GC Services for UK King's Daughters Medical Center – Greenup Co. Urgent Care/Family Care Medical Office Building

ADDENDUM # 01

GREENUP COUNTY URGENT CARE / FAMILY CARE MEDICAL OFFICE BUILDING

The Addendum will form a part of the Proposal Documents and modifies the original Proposal Documents dated May 1, 2026.

C RADIATION SHIELDING PLAN
1/4" = 1'-0"

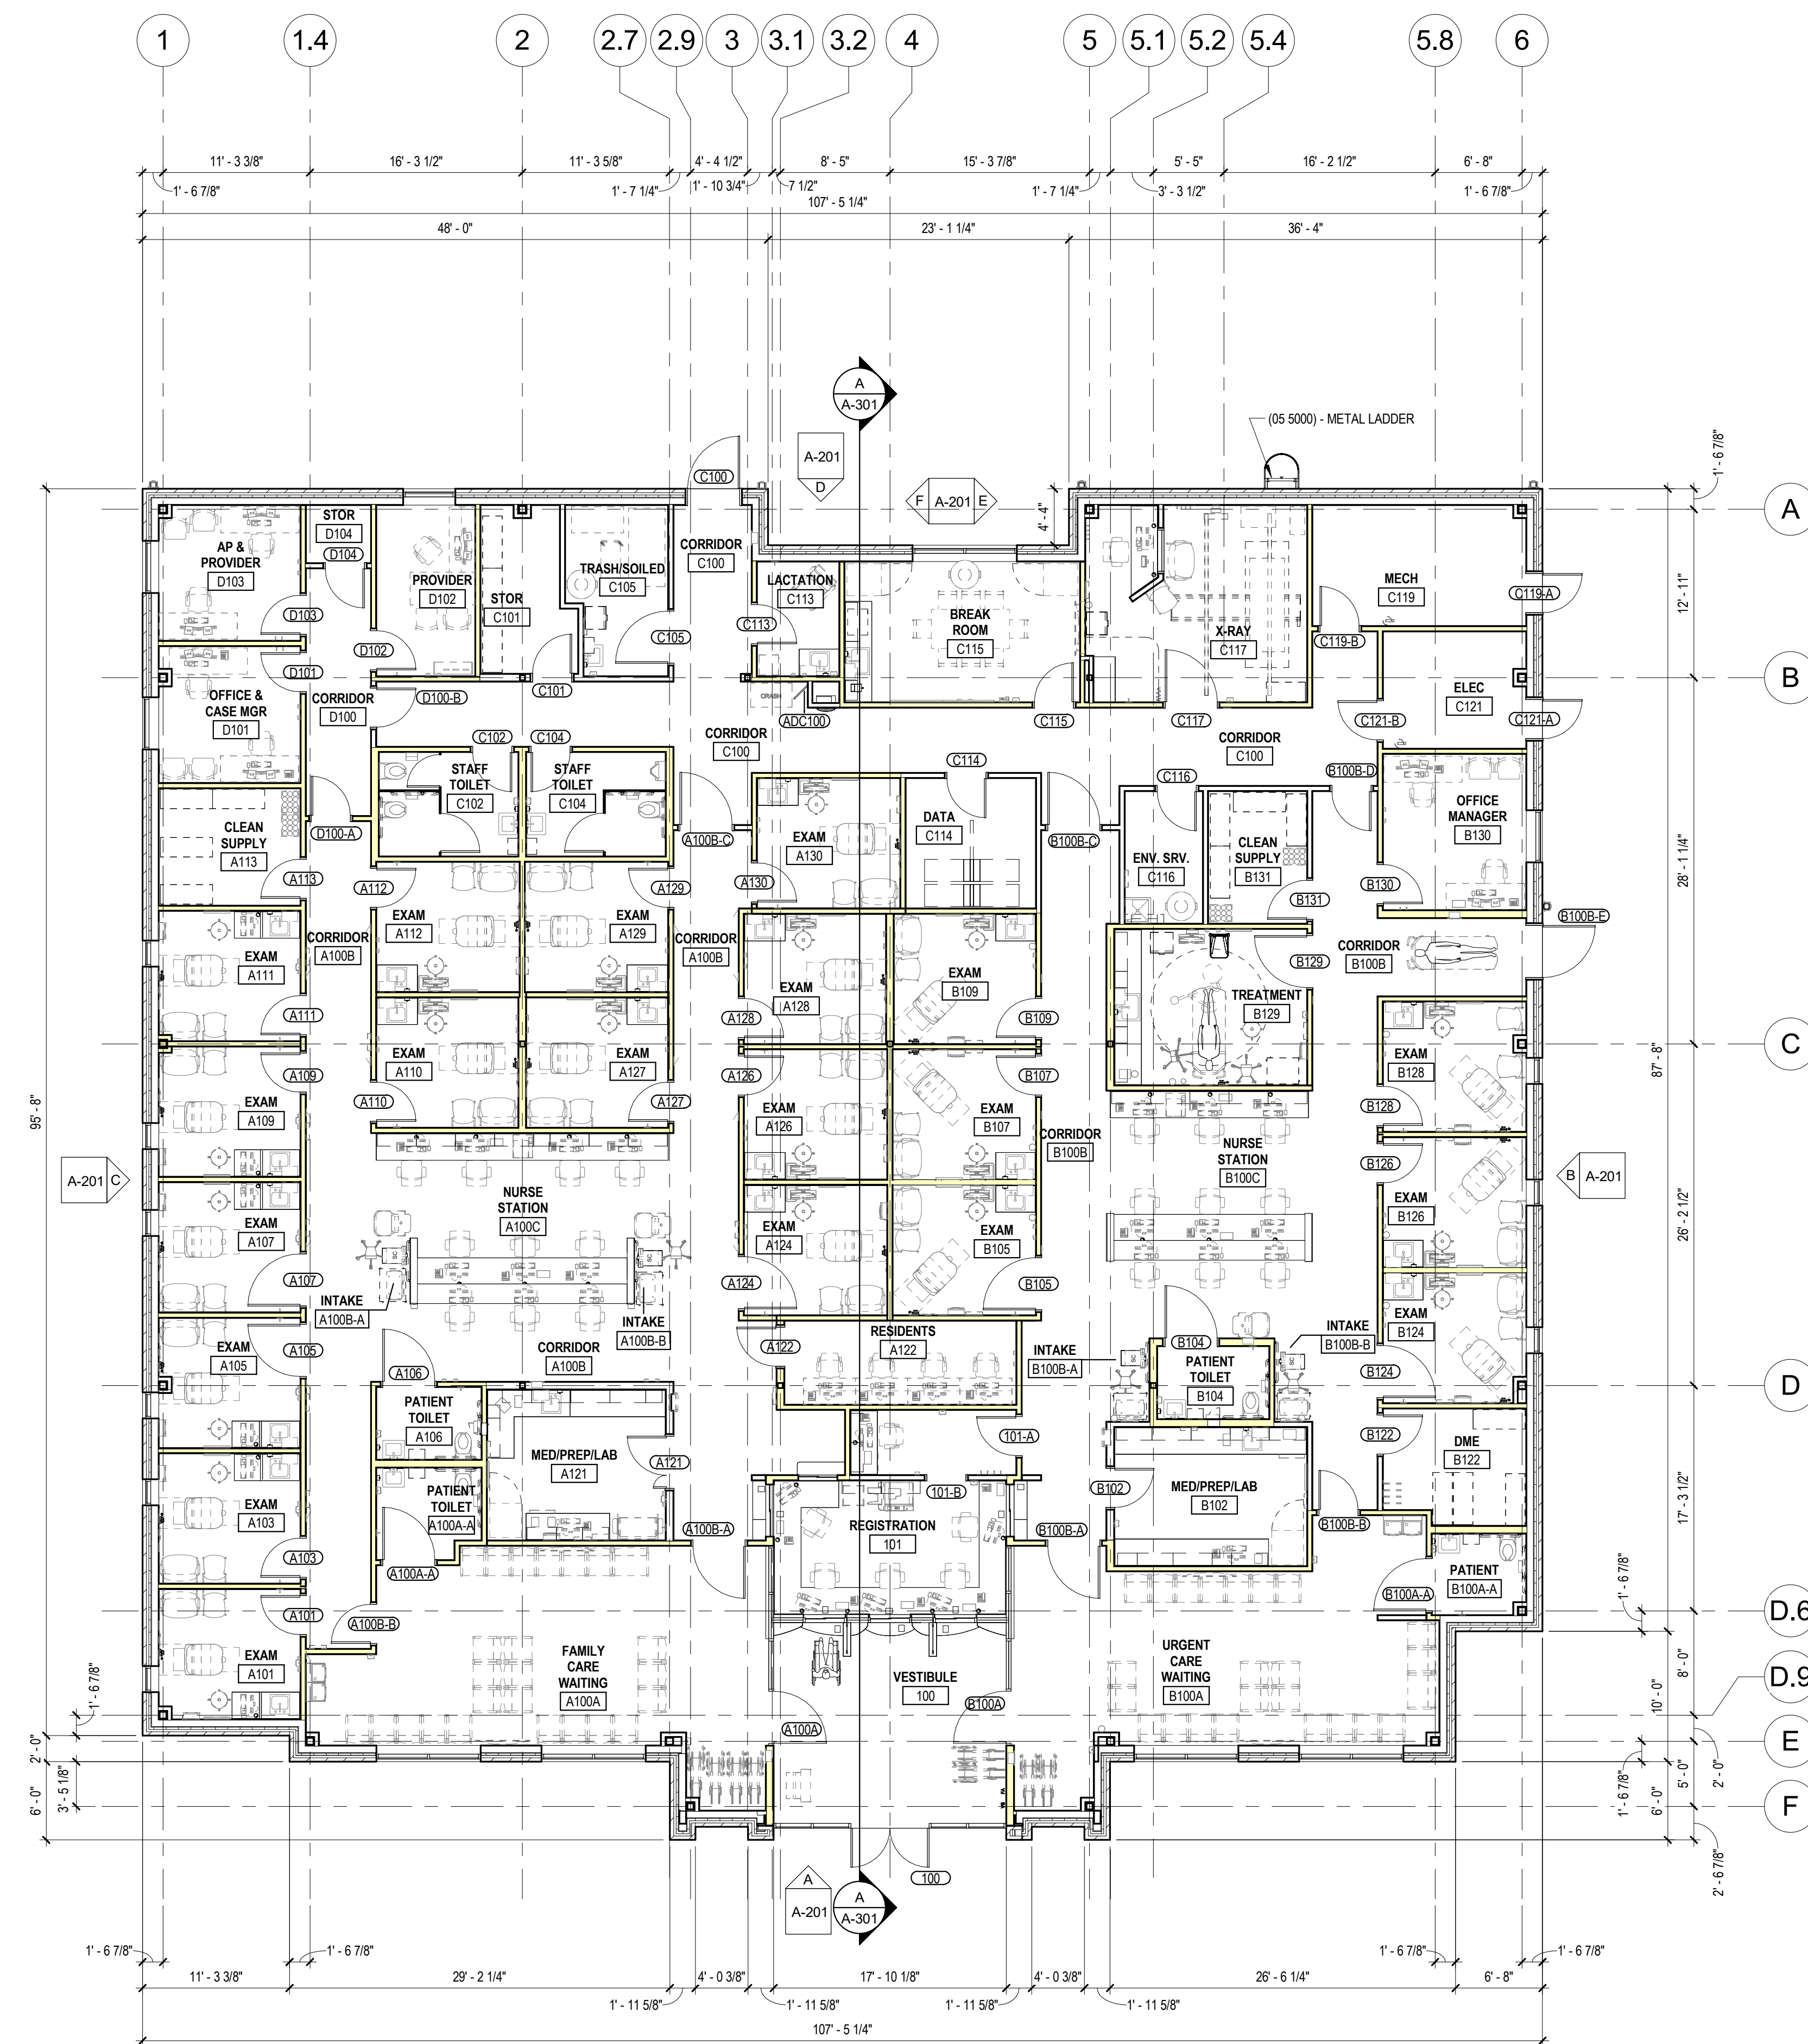
Refer to the attached revised Sheet A-101 for revisions to the Radiation Shielding Plan.

A-111

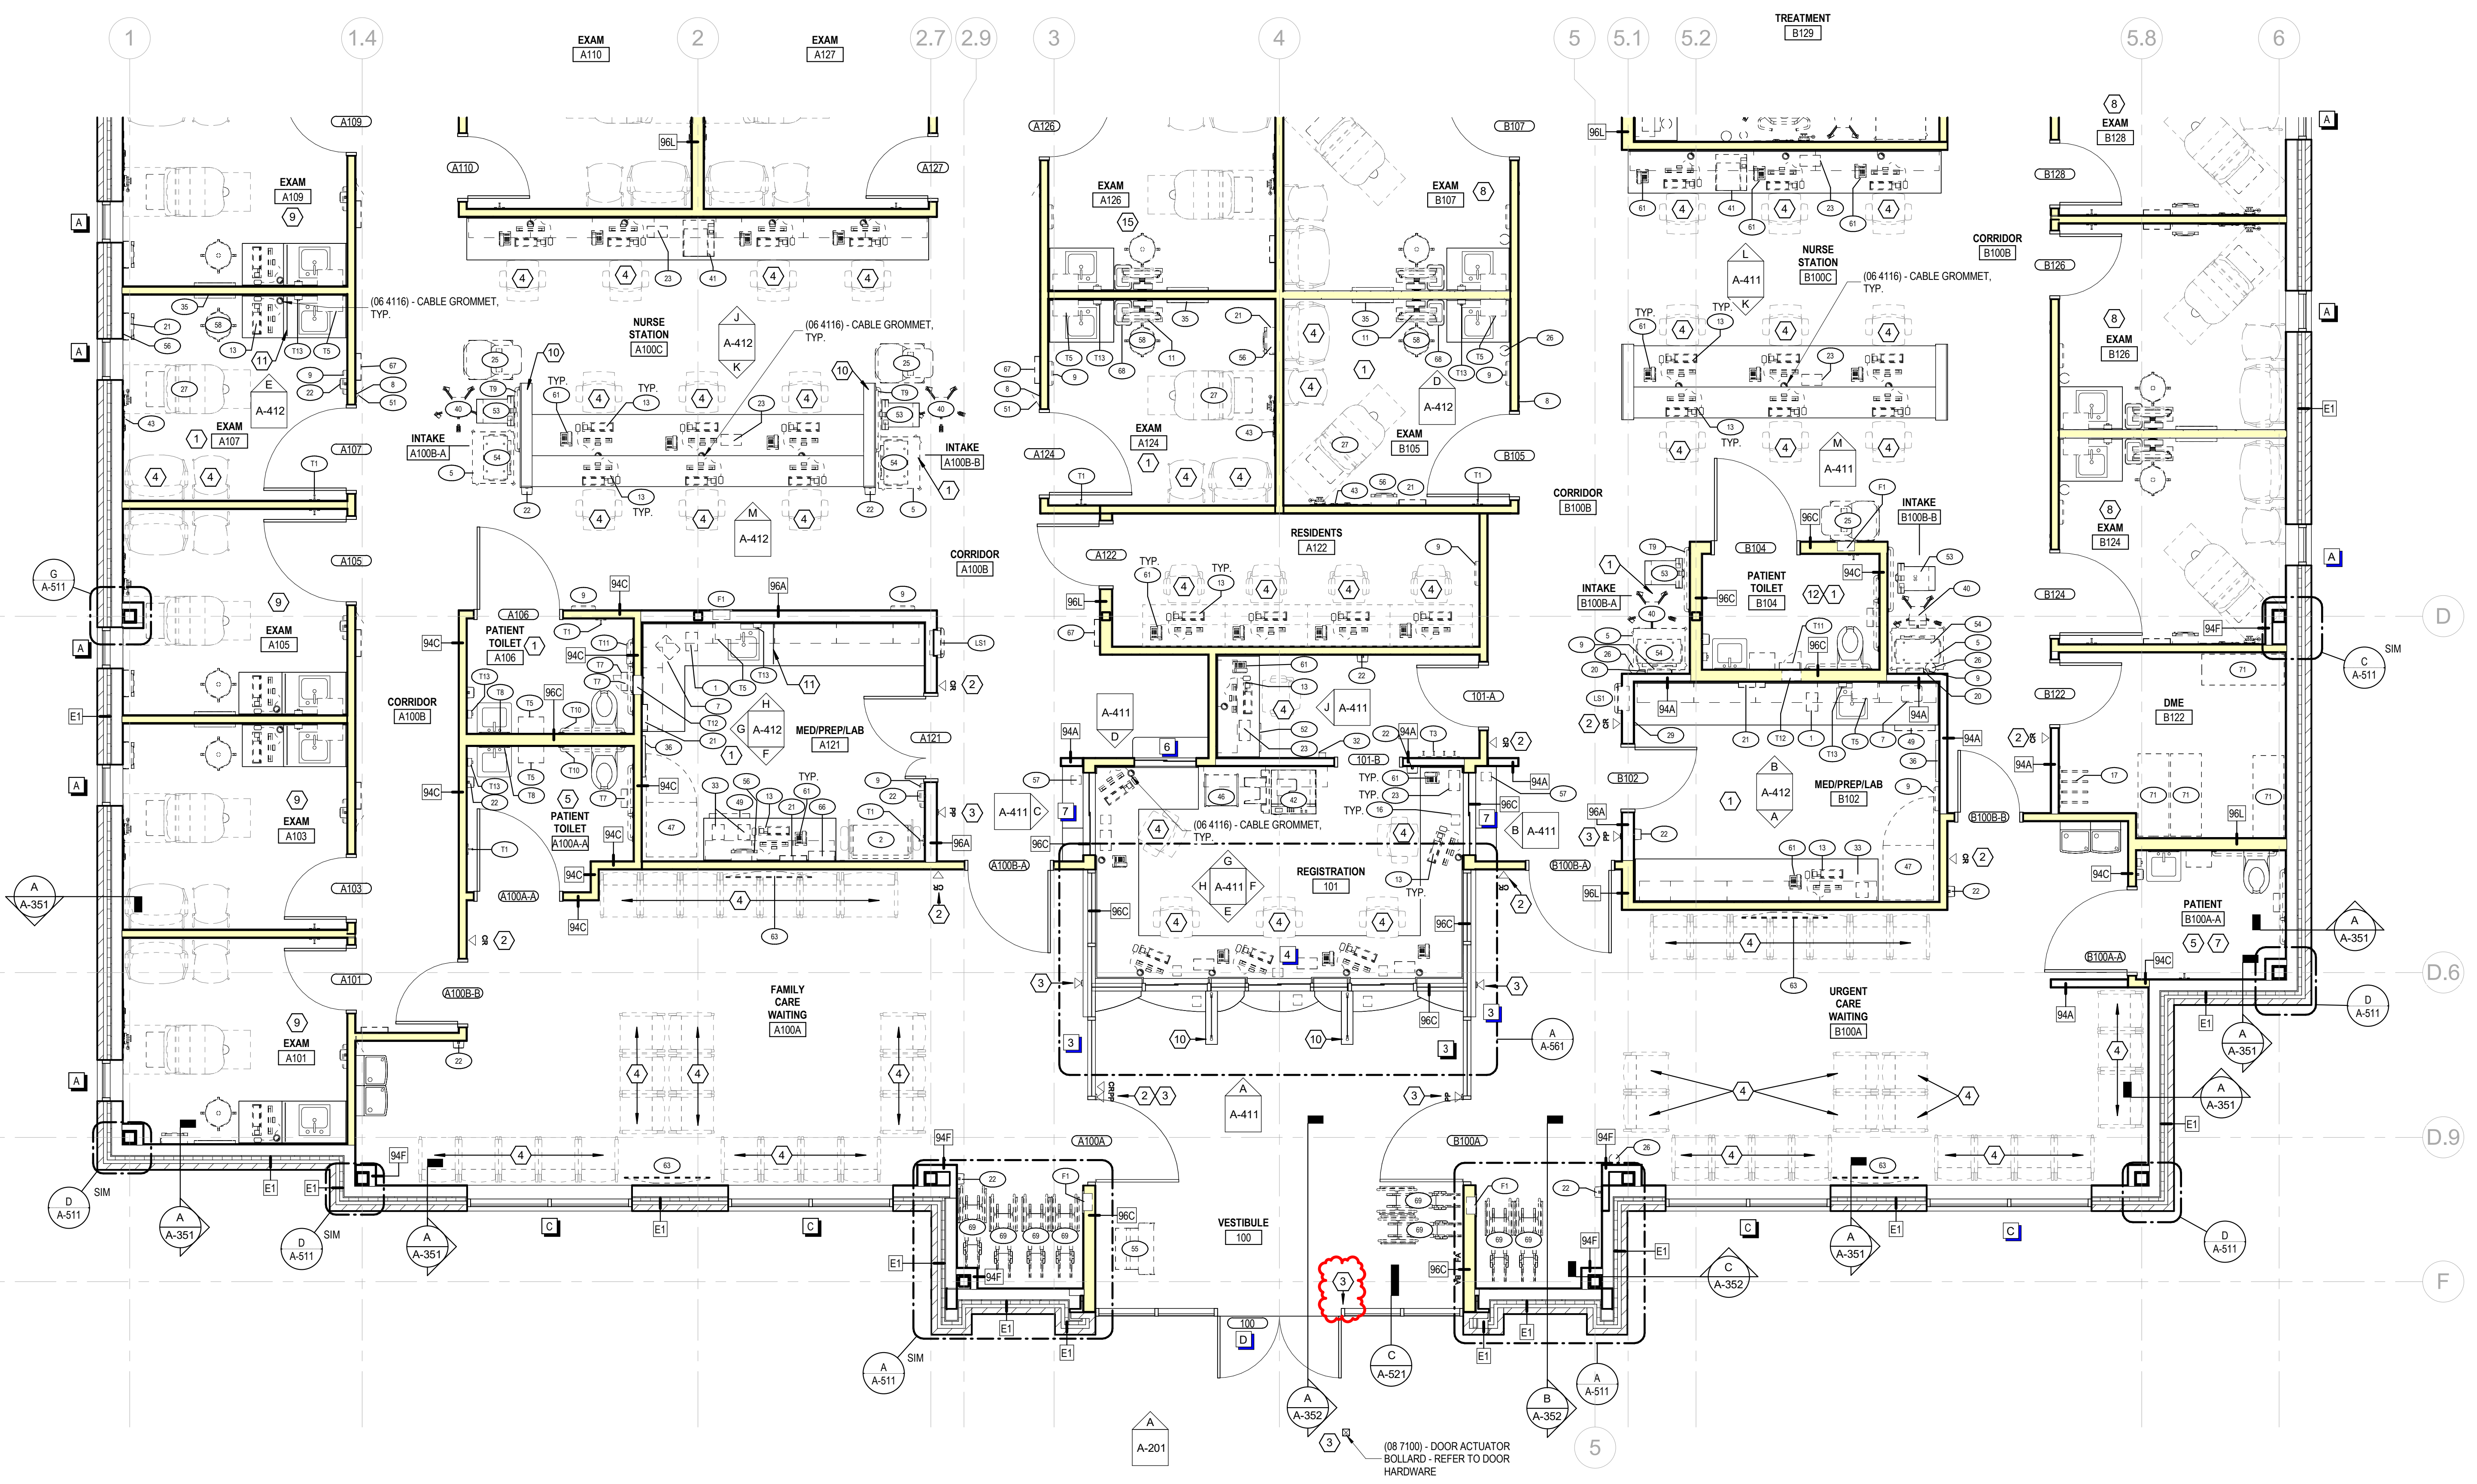
Refer to the attached revised Sheet A-111 for added keynote to align with electrical drawings and door hardware.
